PLANNING AND ZONING CASE CHECKLIST

Project Number SP2019-037
Project Name Ridge Road Retail Center
Type SITE PLAN
Subtype
Status P&Z HEARING

| Type of Review / Notes | Contact | Sent | Due | Received | Elapsed Status | Remarks |
|--|---------|------|-----|----------|----------------|---------|
| SP2019-037; Site Plan for Ridge Road Retail Center (PD-32) | | | | | | |

| Type of Review / Notes | Contact | Sent | Due | Received | Elapsed Status | Remarks |
|--|---------|------|-----|----------|----------------|---------|
| SP2019-037; Revised Submittal-- Site Plan for Ridge Road Retail Center(PD-32) | | | | | | |

1
 A3.2 **TRASH ENCLOSURE**
 SCALE: 1/4"=1'-0"

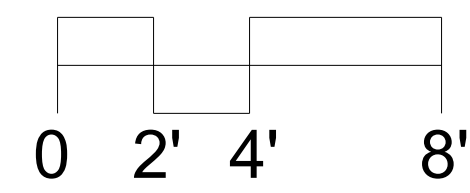
| Type of Review / Notes | Contact | Sent | Due | Received | Elapsed Status | Remarks |
|--|----------------|------------|------------|-----------|----------------|------------------------|
| M.13 Based on the submittal staff has identified the following variances 1) Building Materials. The proposed addition does not meet the minimum of 20% stone. 2) Dumpster Enclosure. The proposed relocation of the dumpster enclosure faces a public street To be able to request a variance, an applicant needs to provide a letter stating the justification for each variance requested and indicate a minimum of two (2) compensatory measures for each that directly tie to off-setting the impact of the variance. Please also note that all of the requested variances will require a simple majority vote for approval. Refer to Section 9, of Article XI, of the UDC for examples of compensatory measures. | | | | | | |

Sheet
SP-1

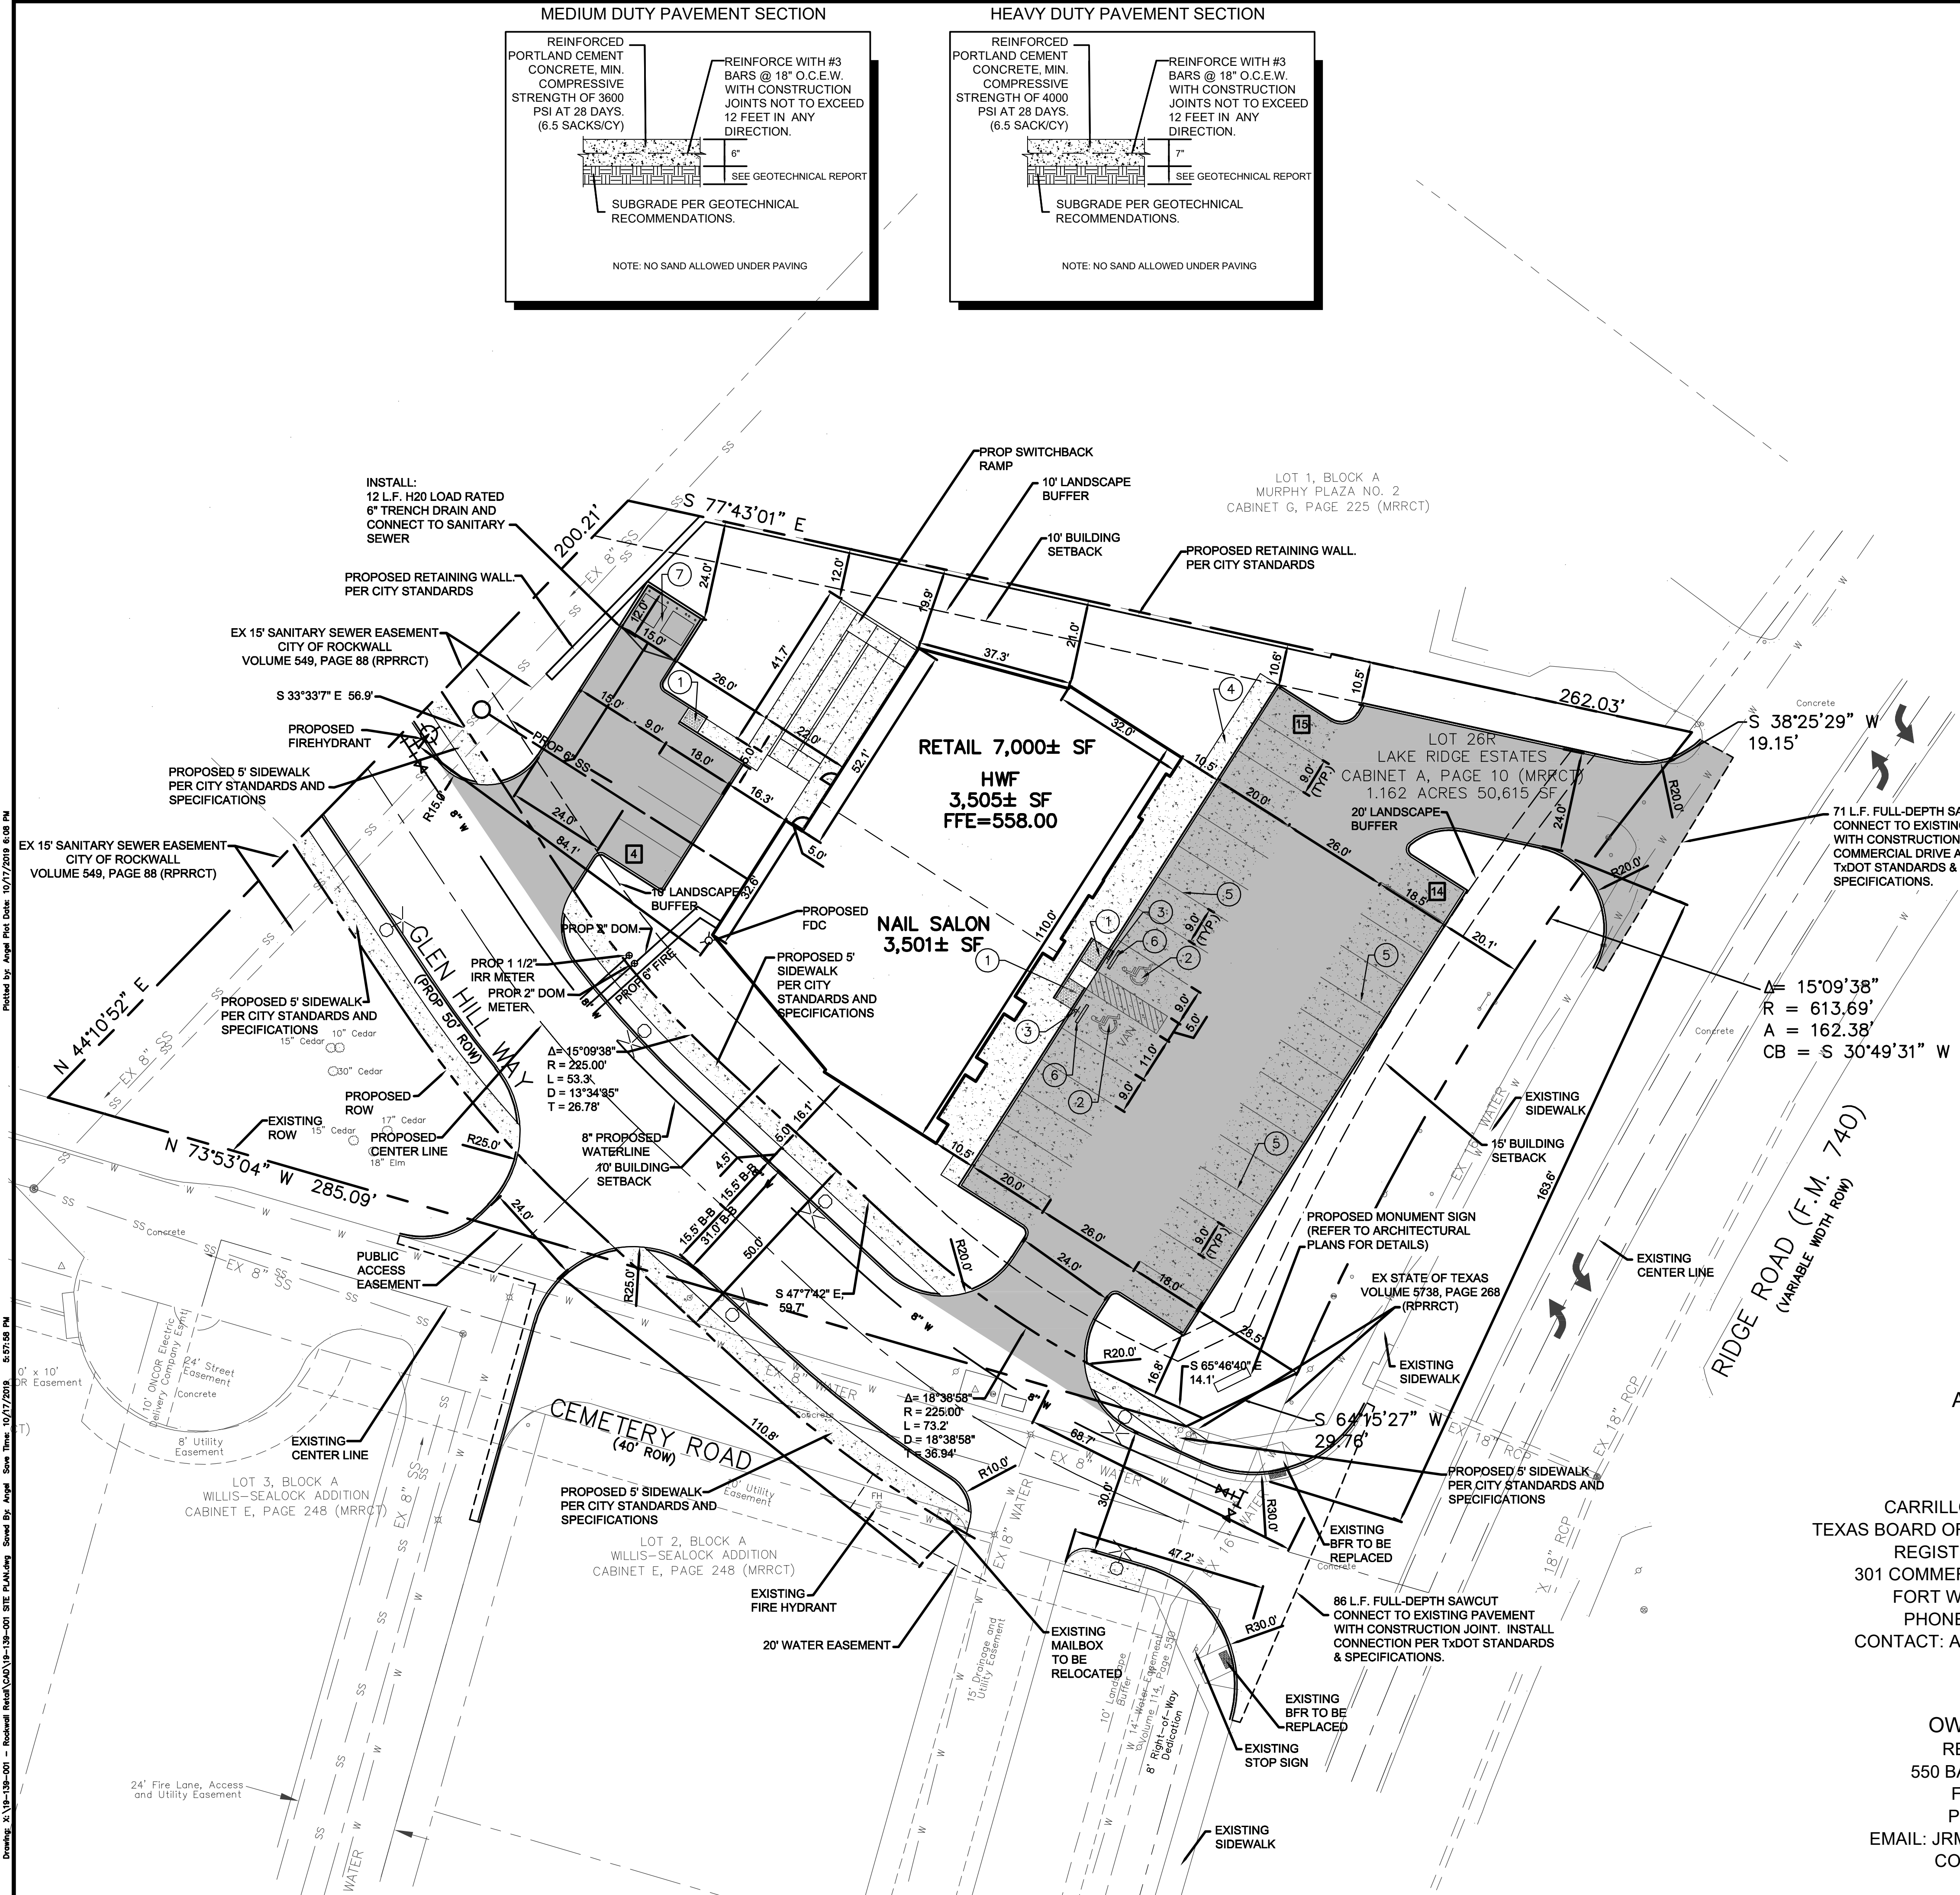
| Type of Review / Notes | Contact | Sent | Due | Received | Elapsed Status | Remarks |
|--|---------|------|-----|----------|----------------|---------|
| M.8 Site Plan. Please make the following clarifications on the site plan to ensure staff can properly review this project and convey all of the required elements to the City's boards and commissions: | | | | | | |
| 1) Under the Construction Schedule legend No. 7, change the minimum dumpster enclosure to indicate 8-ft. | | | | | | |
| 3) Provide a standard signature block with signature space for the Planning and Zoning Chairman and Planning Director. | | | | | | |

1 LANDSCAPE PLAN
 1"=20'-0"

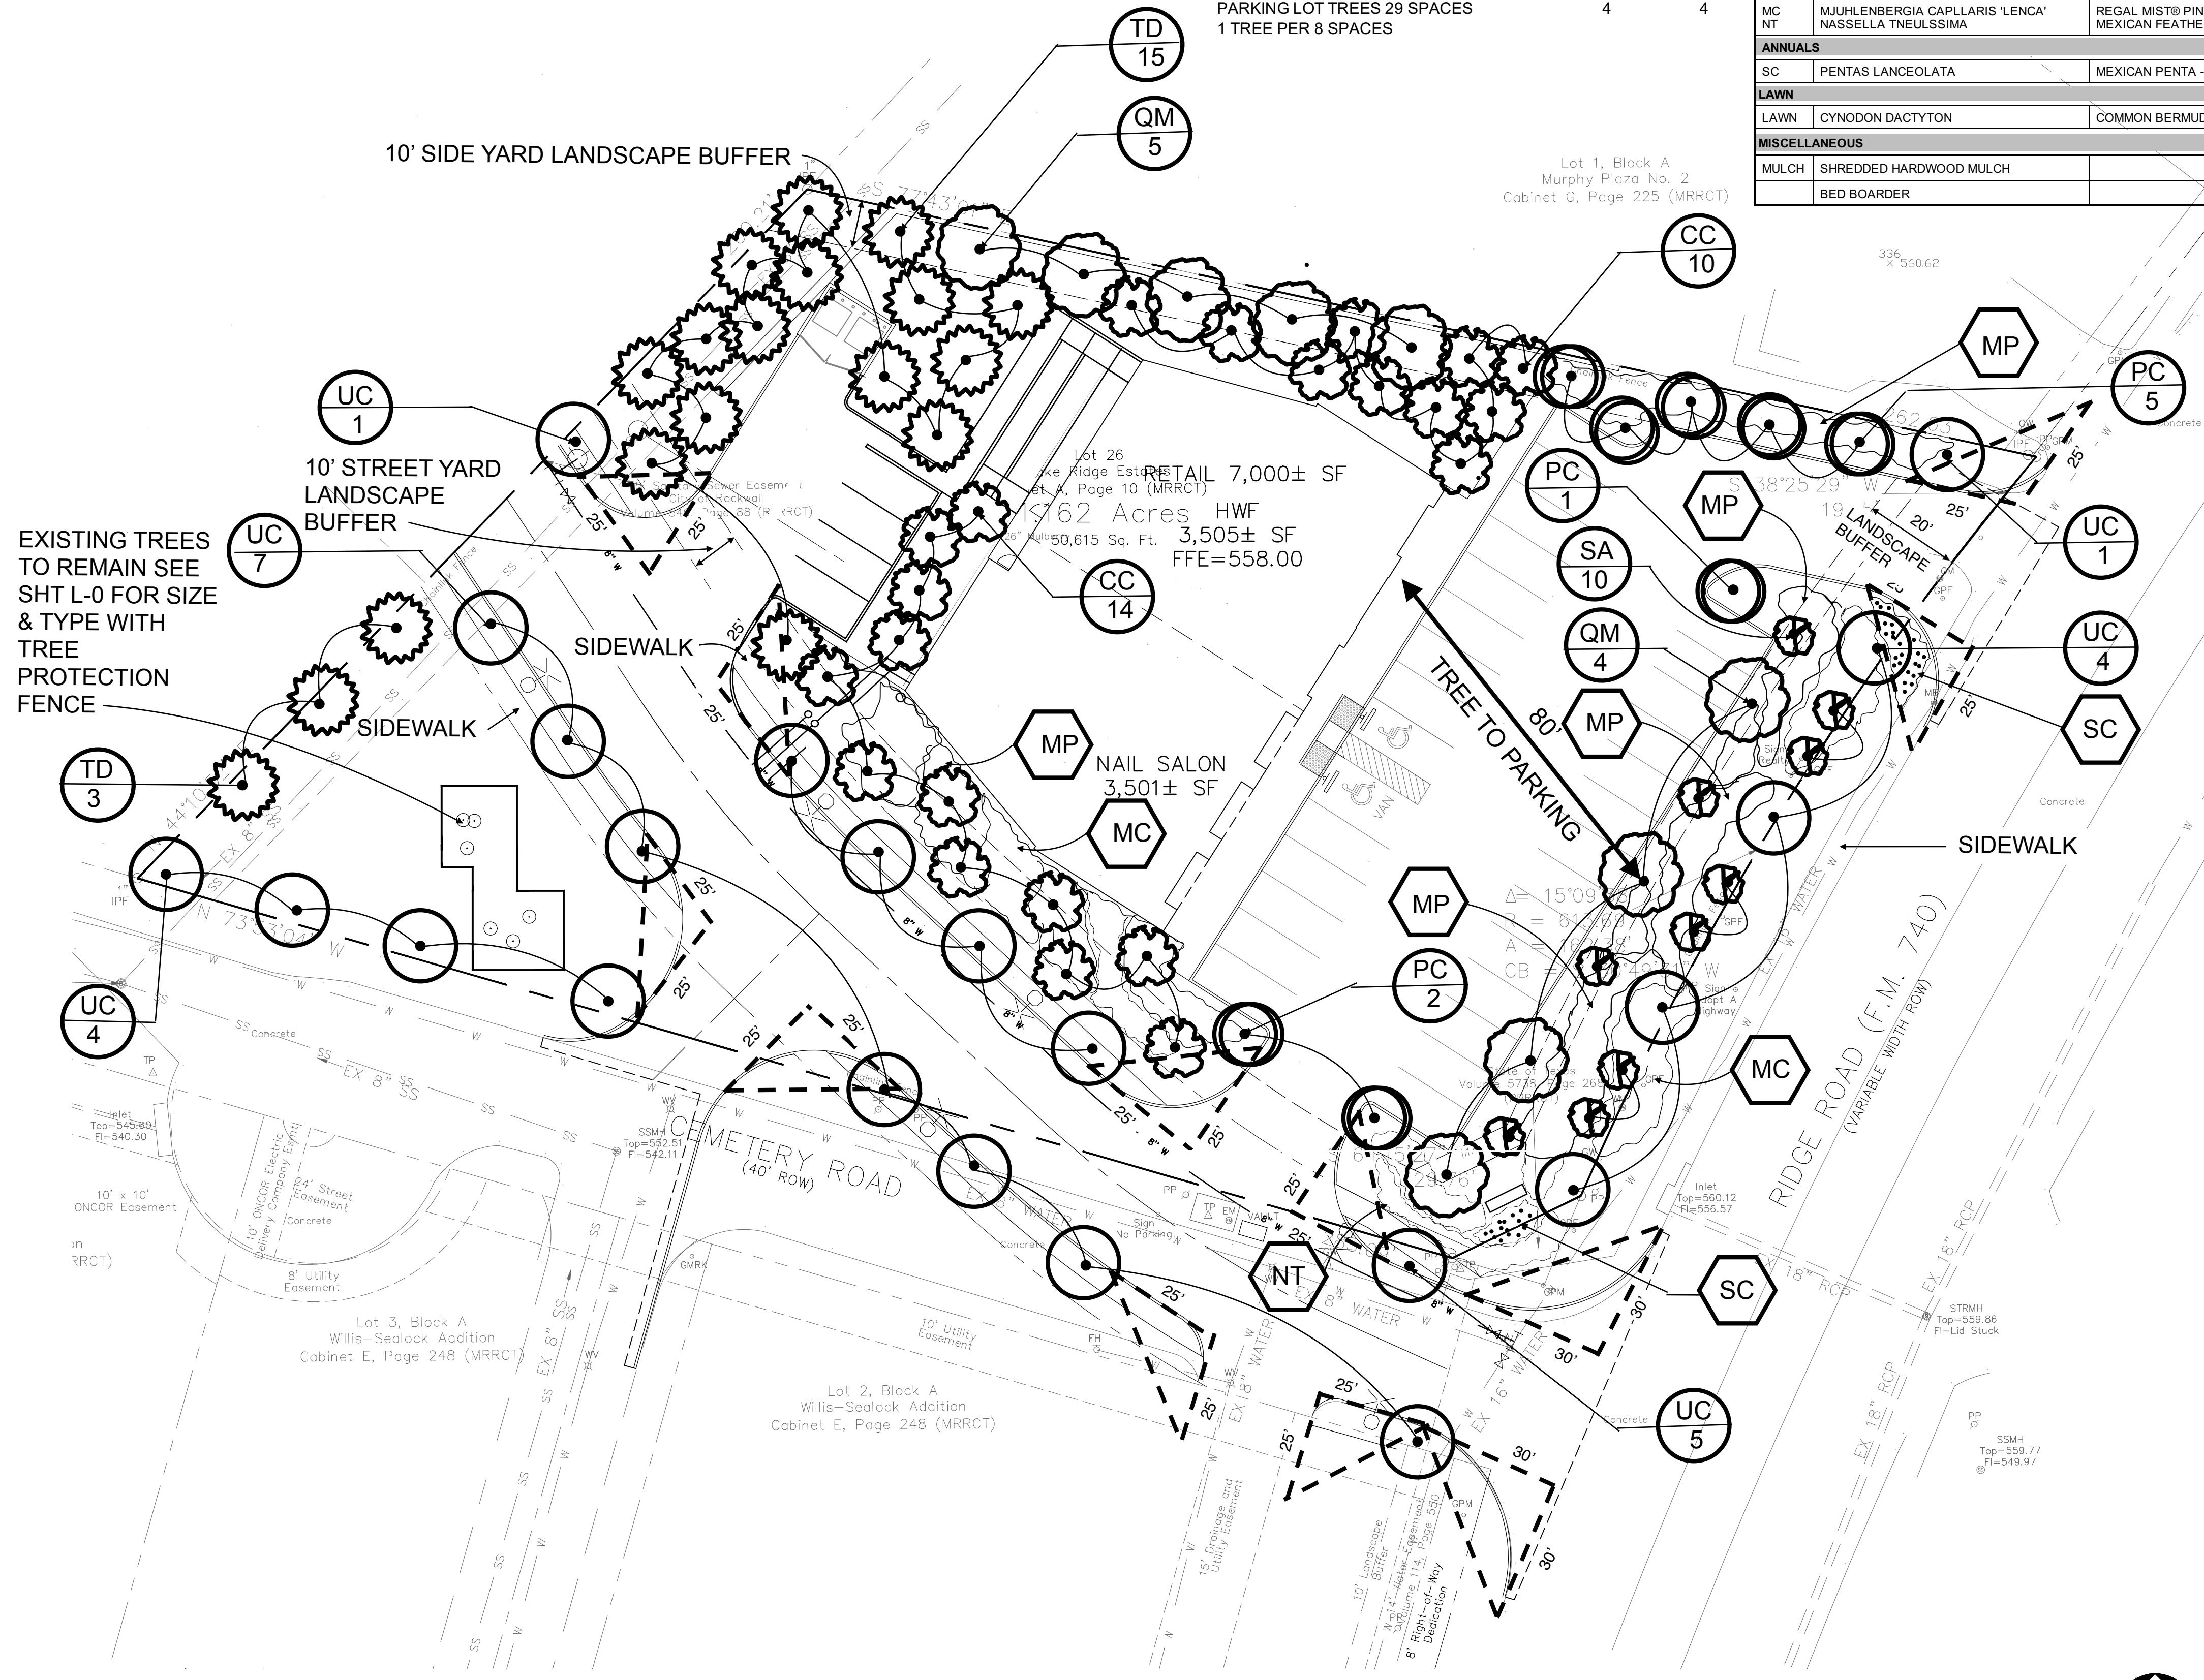
| Type of Review / Notes | Contact | Sent | Due | Received | Elapsed Status | Remarks |
|--|----------------|------------|------------|-----------|----------------|------------------------|
| M.11 Landscape Plan. Please make the following clarifications and changes to the landscape plan to ensure staff can properly review this project and convey all of the required elements to the City's boards and commissions: 1) Please provide an exhibit showing headlight screening for the head-in parking adjacent to the street (Subsection 5.02(C), Art. VIII, UDC). | | | | | | |
